**City of Ferndale
Well Water Supply Project
ADDENDUM NO. 1
March 28, 2011**

You are hereby notified of the following additions to the Plans, Specifications and other documents comprising the Contract Documents for the City of Ferndale, Well Water Supply Project.

Page 17-17, 3.D Backwash Operations

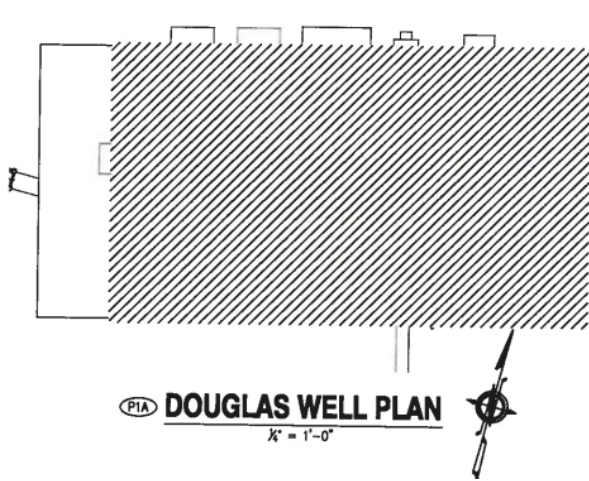
Air Scour Process

At the start of the air scour process, the filter cell's effluent valve will close and the air supply valve [A-006 to A-013] will open. The blower [B-501] will turn on and provide air to the filter at 170 scfm for an operator adjustable duration, initially set at 5 minutes.

After an operator adjustable ~~duration~~ **delay**, initially set at 4 minutes, open the backwash supply valve and start the backwash supply pump [P-701]. Gradually increase the backwash water rate up to **an operator adjustable flow rate, initially set at 280 gpm**, until the air scour duration has completed.

Page 2 of 75 with Error

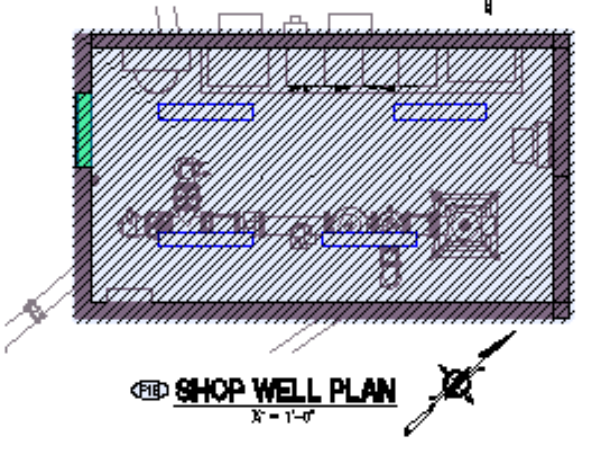
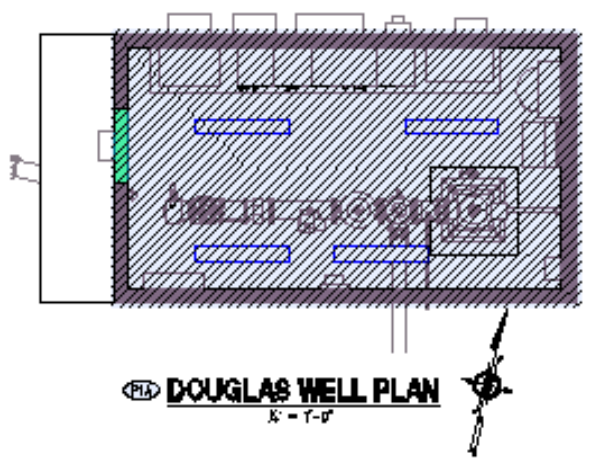
Print sets from Applied Digital Imaging produced prior to March 26, 2011 may have print errors on them due to printer driver software conflicts with Autodesk Design Review 2011 ® software. Examples of such errors are shown below. All planholders prior to March 26, 2011 will be provided with a new 1/2 size color planset without charge. We apologize for the inconvenience. If planholders are utilizing the downloaded pdf or dwf plansets from WCR Publications, please check any printed sets to verify they are printed correctly. Note colors may not match as the errors are scans of printed material and corrections are from the dwf planset.

Page 2 of 75 printed correctly
